City of Oakley
ADDENDUM NO. 1 to contract documents for
OAKLEY COMMUNITY DOG PARK – PHASE 1 PARKING LOT
PROJECT, CIP # 197

BID OPENING DATE: June 29, 2017 2:00 PM

Notice is hereby given that the following clarifications and revisions are made to the above referenced contract documents:

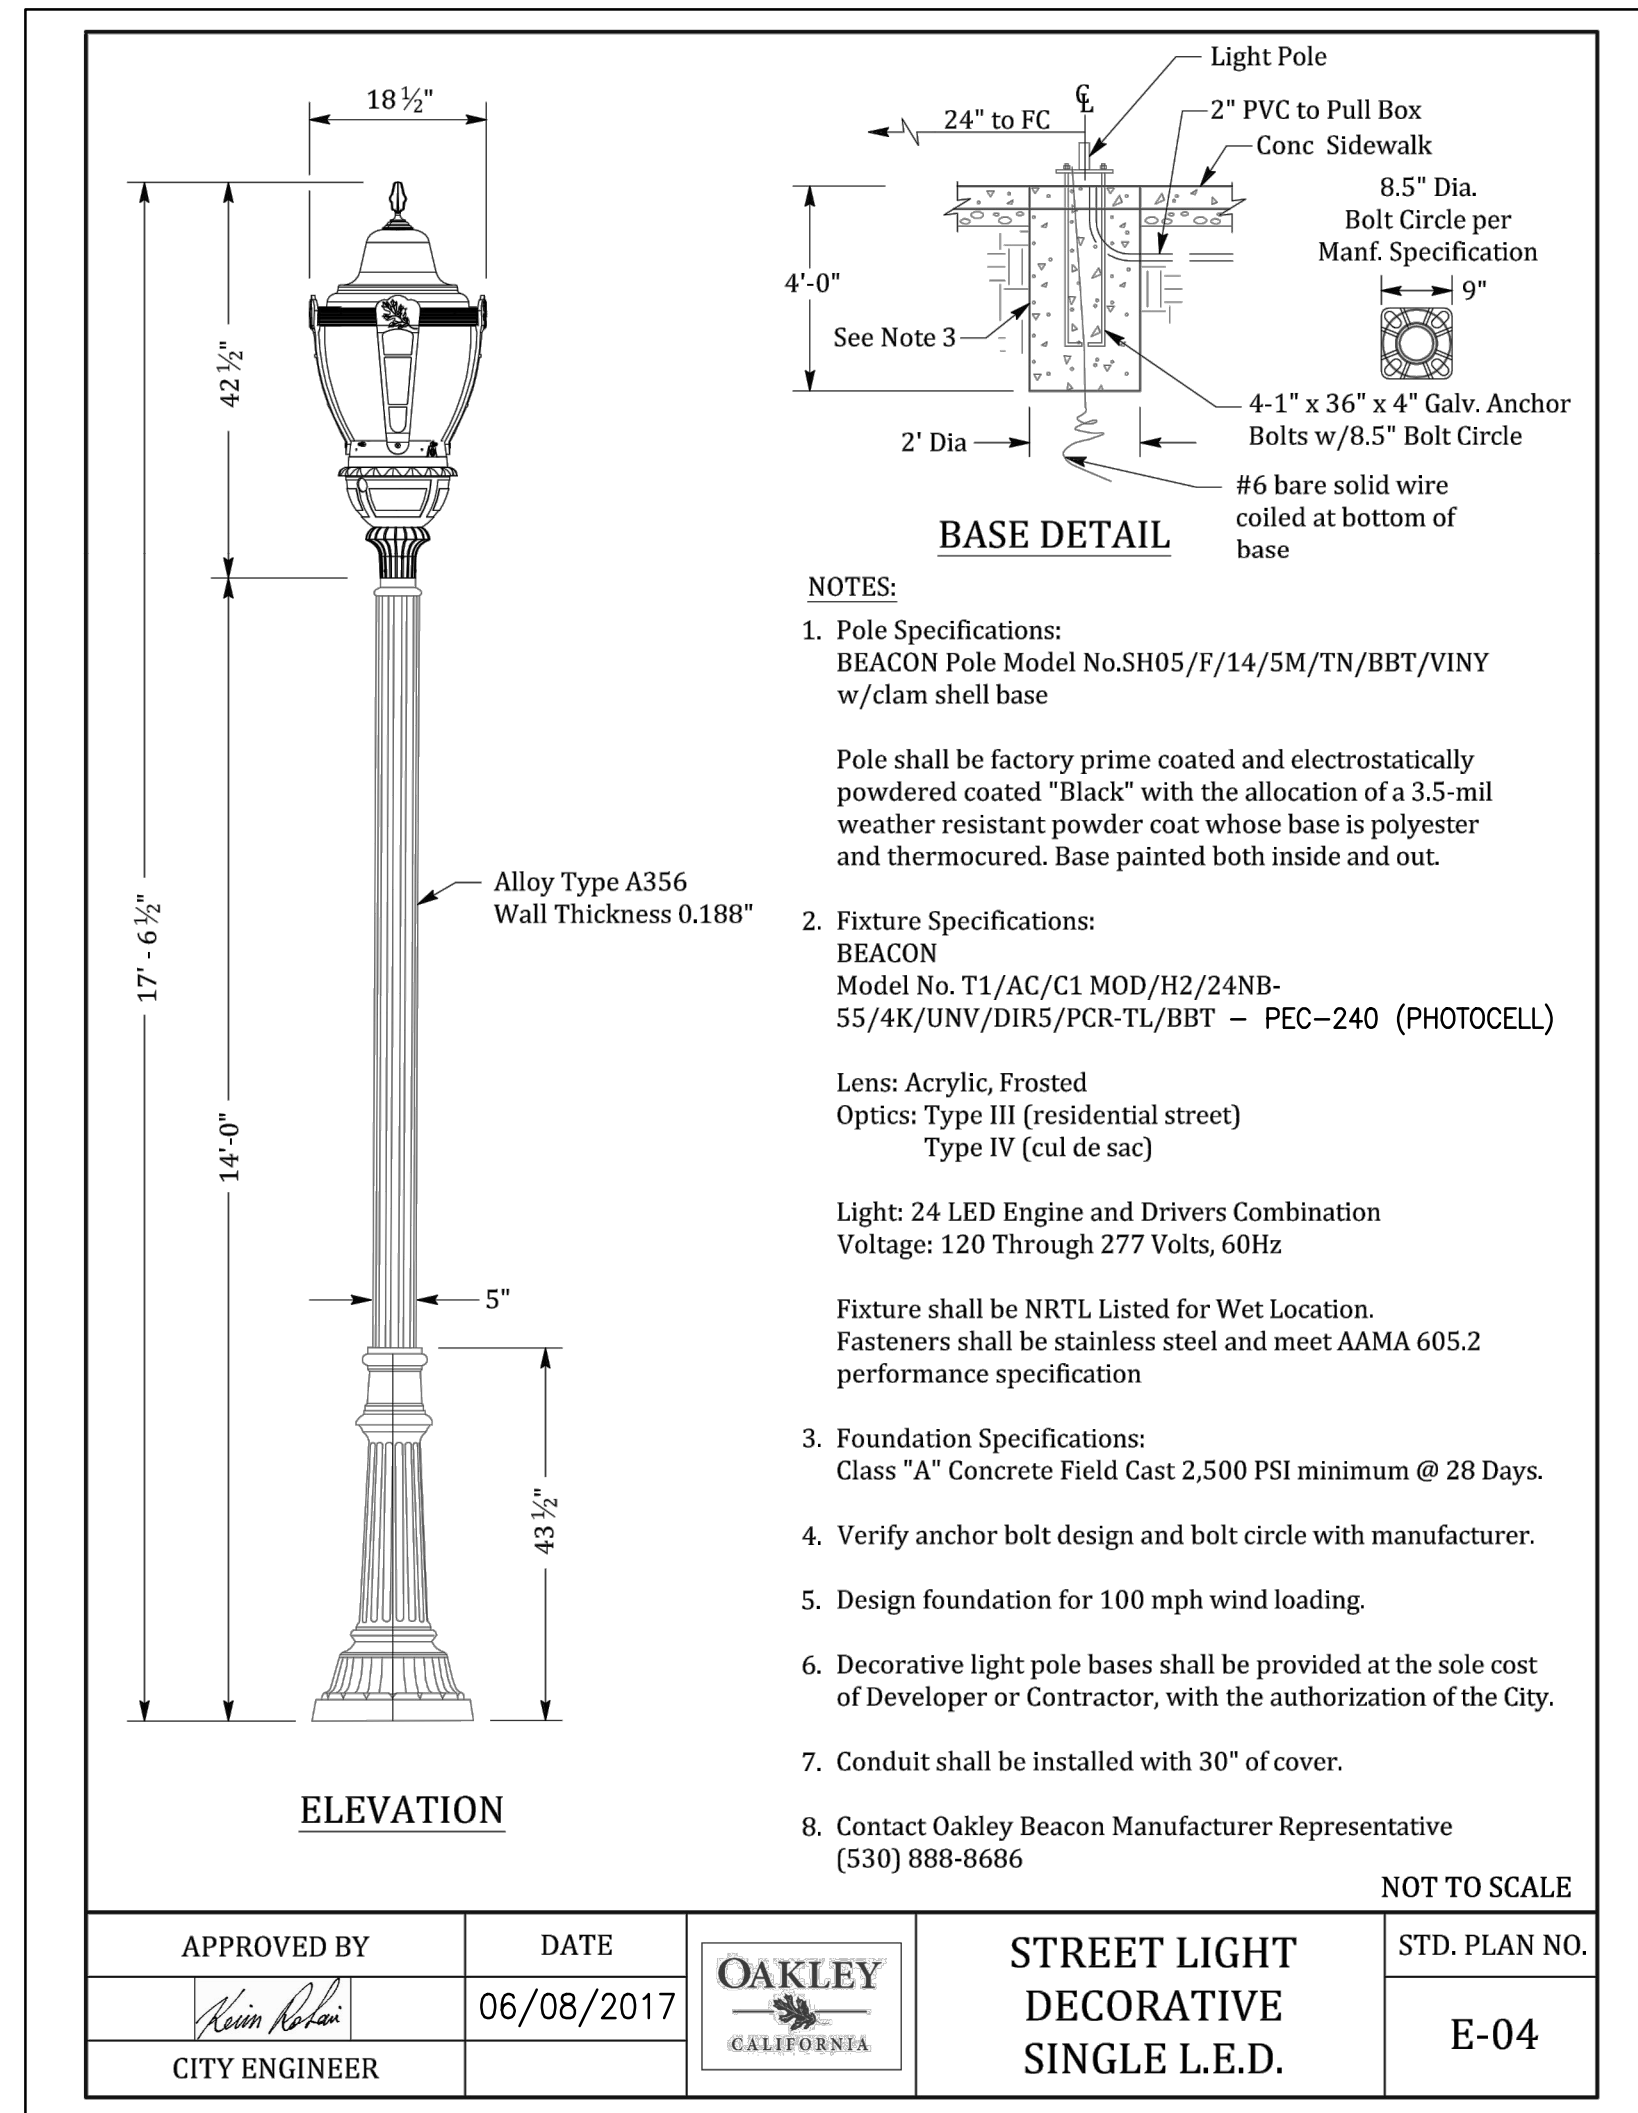
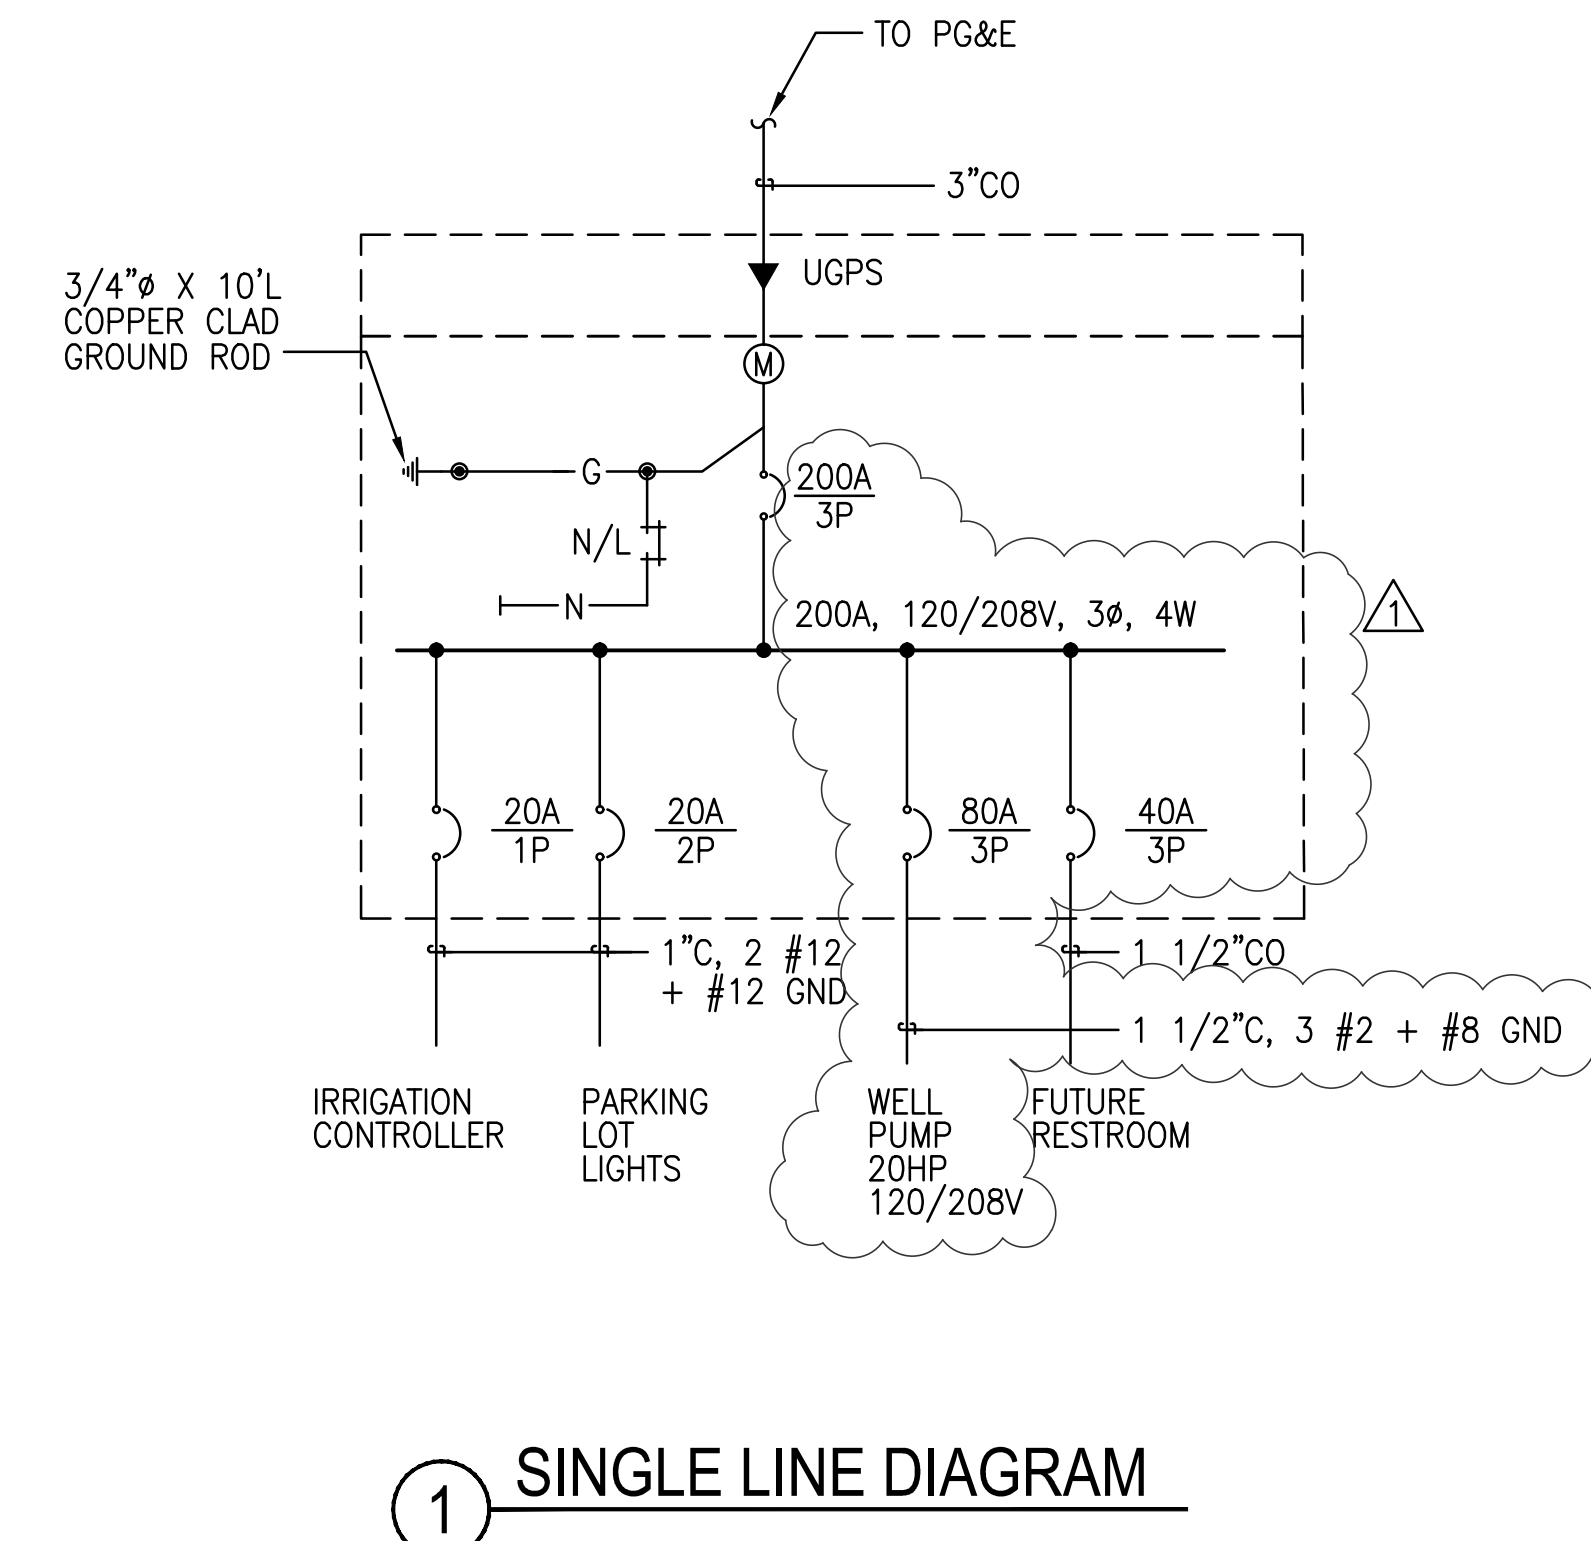
Sheet E1.0 & E2.0

- o Electrical single phase updated to 3 phase converter for the PG&E electrical connection, as shown on pages E1.0-2.0. The service is shown on the drawing at 200 amp 120/208 volts three phase four wire, which will be able to handle any changes in the hp rating of the motor.
